SUBDIVISION REVIEW SHEET**CASE NO.:** C8-2016-0216.0A**ZAP DATE:** January 2, 2018**SUBDIVISION NAME:** Allen Terrace Subdivision**AREA:** 1.98**LOT(S):** 5**OWNER/APPLICANT:** (John Dan McMahan III and Artemis Land Partners)**AGENT:** (Rivera Engineering)**ADDRESS OF SUBDIVISION:** 1401 Allen Road**GRIDS:** MF22**COUNTY:** Travis**WATERSHED:** Eanes Creek**JURISDICTION:** Full-Purpose**EXISTING ZONING:** SF-2**MUD:** N/A**NEIGHBORHOOD PLAN:** N/A**DISTRICT:** 8**PROPOSED LAND USE:** Single Family**ADMINISTRATIVE WAIVERS:** n/a

SUBJECT: C8-2016-0216.0A Allen Terrace Subdivision, Flag Lot variance request

ALLEN TERRACE SUBDIVISION

PROTECTION PLAN

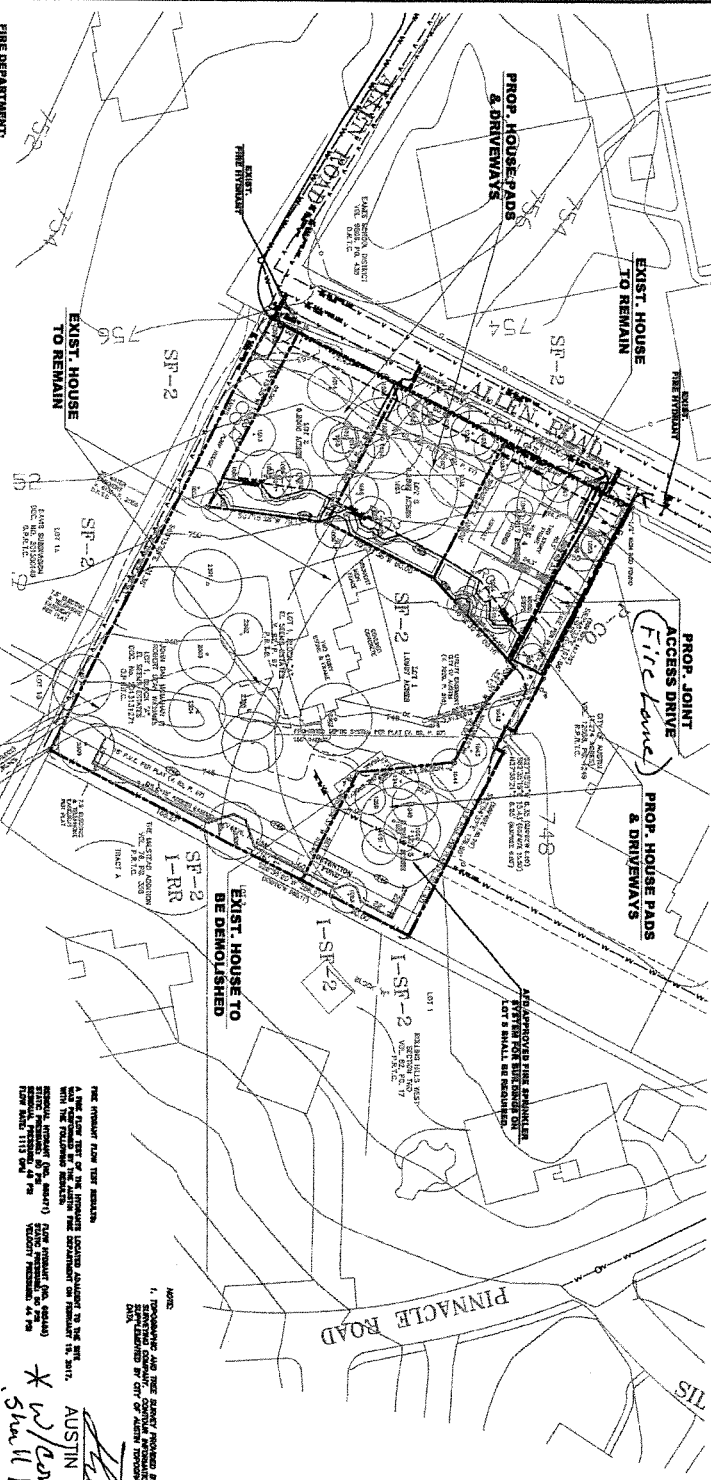
Thomas M. P. 8/2/2017
AUSTIN FIRE DEPARTMENT FIRE PREVENTION DIVISION
* w/ comment: pavement design
shall be provided with subdivision
driveway permits.
bldg permits.
